**Economic Commission for Europe****Inland Transport Committee****World Forum for Harmonization of Vehicle Regulations****Working Party on General Safety Provisions****128th session**

**Awareness of the Proximity of Vulnerable Road Users:  
UN Regulation No. 46 (Devices for Indirect Vision)****Proposal for the 07 Series of Amendments to Regulation  
No. 46 (Devices for Indirect Vision)****Submitted by the expert from Germany on behalf of the Task Force on  
UN Regulation No. 46\***

**Figure 1a**

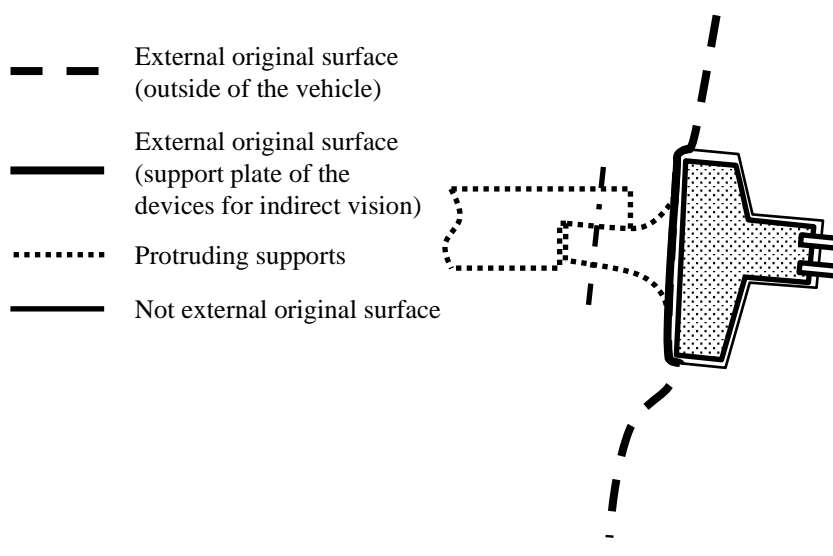
Paragraph 2.7., amend to read:

- "2.7. "*External original surface*" means the outside of the vehicle including the bonnet, the lid of the luggage compartment, the doors, the wings (**fender**), the roof, the lighting and light-signalling devices, the visible strengthening components, **the support plate of devices for indirect vision** and additional external original design surfaces defined by the manufacturer excluding protruding supports for devices of indirect vision.

8. Clarification on external original surface: A drawing shall be added to further explain the idea of "external original surface". Additionally, the wording in paragraph 6.1.1.6. shall be amended for clarity.

**Figure 1b  
Example for the Measurement by Maximum Variation**

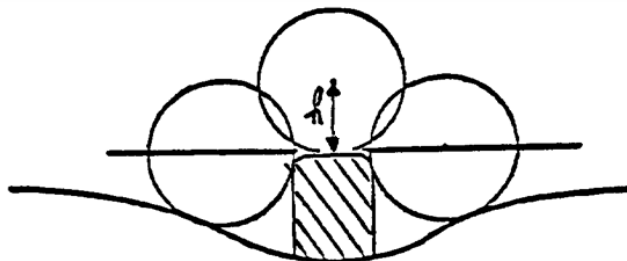
Paragraph 6.1.1.4.2., amend to read:

"6.1.1.4.2. If the dimension of the projection of a component which is mounted on a surface other than convex cannot be determined by simple measurement, it shall be determined by the maximum variation of the distance of the centre of a 100 mm diameter sphere from the nominal line of the panel when the sphere is moved over and is in constant contact with that component. Figure 1b shows an example of the use of this procedure.

10. Wrong Reference: A reference in paragraph 15.2.1.1.3. is corrected.
  11. Correct the numbering of the figures: In the current version there are two different figures numbered 1. As a new figure shall be introduced, the new one becomes figure 1a and the former figures 1 become 1b and 1c.
-

Figure 1b  
**Example for the Measurement by Maximum Variation**

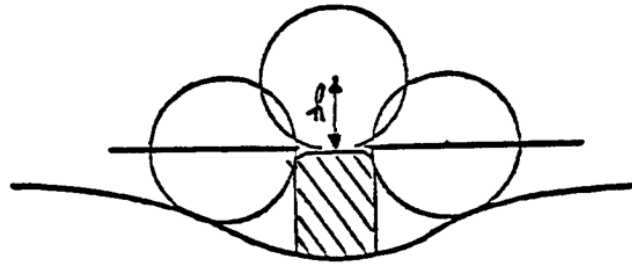
Paragraph 6.2.2.1.2.2., amend to read:

"6.2.2.1.2.2. If the dimension of the projection of a component which is mounted on a surface other than convex cannot be determined by simple measurement, it shall be determined by the maximum variation of the distance of the centre of a 100 mm diameter sphere from the nominal line of the panel when the sphere is moved over and is in constant contact with that component. Figure 1b shows an example of the use of this procedure.

Figure 1c

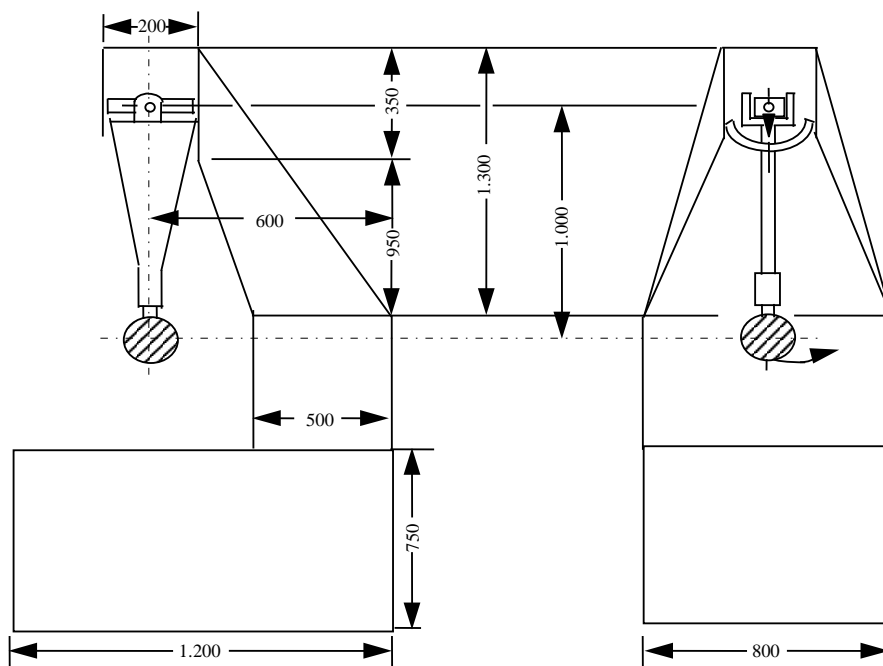
Paragraph 6.3.2.1.1., amend to read:

Figure 1c below gives the dimensions (in mm) of the test rig and the special design specifications:

**Example 1**

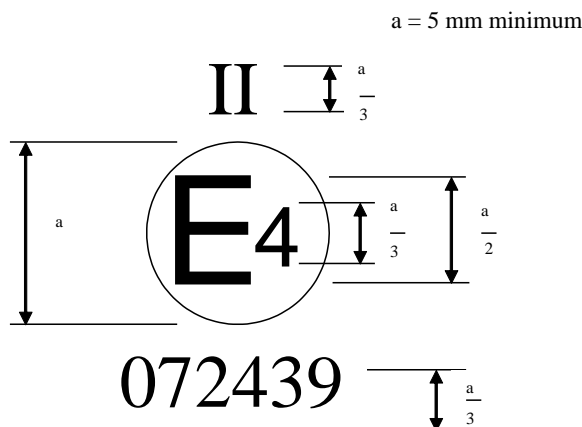
The above approval mark affixed to a device for indirect vision indicates that the device is a main rear-view device, of Class II, which has been approved in the Netherlands (E 4) pursuant to Regulation No. 46 and under approval number ~~052439~~ **072439**. The first two digits of the approval number indicate that Regulation No. 46 already included the ~~05~~ **07** series of amendments when the approval was granted.

**Example 2 One Approval Number for Two Classes**

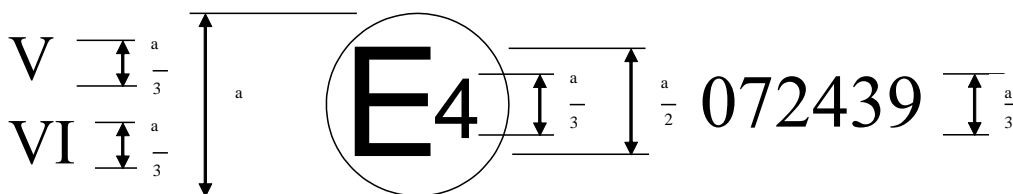
The above approval mark affixed to a device for indirect vision indicates that the device is a close-proximity view device, of Class V, and a front-view device, of Class VI,

which has been approved in the Netherlands (E 4) pursuant to Regulation No. 46 and under approval number 072439. The first two digits of the approval number indicate that Regulation No. 46 already included the 07 series of amendments when the approval was granted.

3. Type-marking: TF decided to introduce the possibility of type-approving devices for more than one Field of View under one approval number. In addition, it shall be possible to combine the marking of devices for indirect view with the marking of other UN Regulations, e.g. UN Regulation No. 10 on electromagnetic compatibility, if applicable.

**Combined Approval Mark for UN Regulation No. 46 and UN Regulation No. 10**

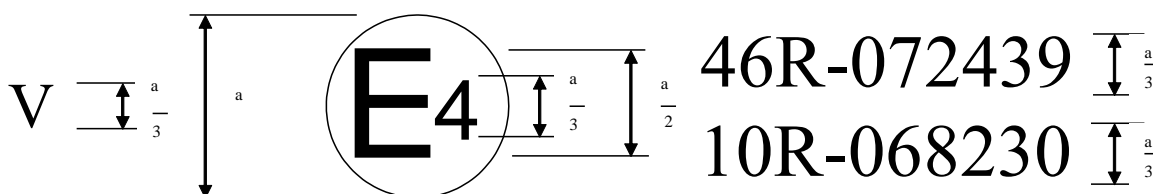
The above approval mark affixed to a device for indirect vision indicates that the device is a close-proximity view device, of Class V, which has been approved in the Netherlands (E 4) pursuant to Regulation No. 46 and under approval number 072439 and pursuant to Regulation No. 10 and under approval number 068230. The first two digits of the approval number indicate that Regulation No. 46 already included the 07 series of amendments and Regulation No. 10 already included the 06 series of amendments when the approval was granted.

**Combined Approval Mark for UN Regulation No. 46 (One Number for Two Classes) and UN Regulation No. 10**

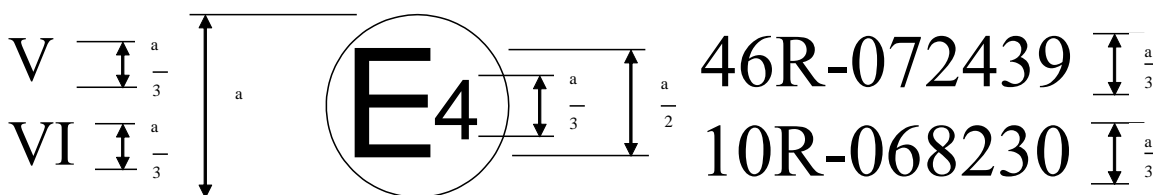
The above approval mark affixed to a device for indirect vision indicates that the device is a close-proximity view device of Class V, and a front-view device of Class VI, which has been approved in the Netherlands (E 4) pursuant to Regulation No. 46 and under approval number 07243946 and pursuant to Regulation No. 10 and under approval number 068230. The first two digits of the approval number indicate that Regulation No. 46 already included the 07 series of amendments and Regulation No. 10 already included the 06 series of amendments when the approval was granted.

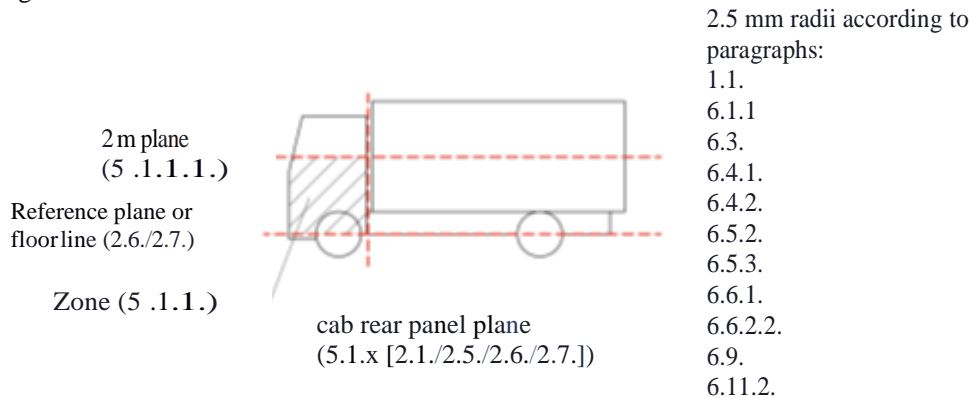
2. Requirements on Surveillance Cameras in UN Regulation No. 46: Surveillance cameras shall be addressed by UN Regulation No. 46 as well. The former decision to have only limited requirements was respected. The proposal takes also into account the specificities for external projections of the different vehicle categories. Vehicles of category M<sub>2</sub> and M<sub>3</sub> do not have any further requirements, vehicles of category N have requirements only on the cab, see below:

UN Regulation No. 61 (External projections of commercial vehicles)

(only N1, N2, N3; does not apply to exterior devices for indirect vision)
